APPLICATION NO.	FILING DATE	FIRST NAMED INVENTOR	ATTORNEY DOCKET NO.	CONFIRMATION NO.
10/767,634	01/29/2004	Kadri Aygun	TRW(ASG)6925	5396
26294	7590	06/20/2006	EXAMINER	
TAROLLI, SUNDHEIM, COVELL & TUMMINO L.L.P. 1300 EAST NINTH STREET, SUITE 1700 CLEVEVLAND, OH 44114				CULBRETH, ERIC D
ART UNIT		PAPER NUMBER		
3616

Office Action Summary	Application No.	Applicant(s)
	10/767,634	AYGUN ET AL.
	Examiner Eric Culbreth	Art Unit 3616

DETAILED ACTION

Fig. 1a

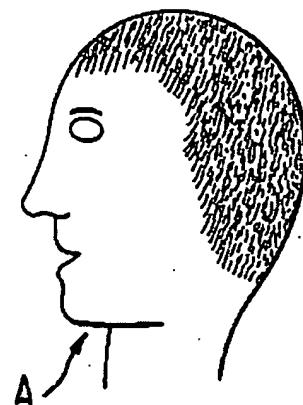
Not
Approved
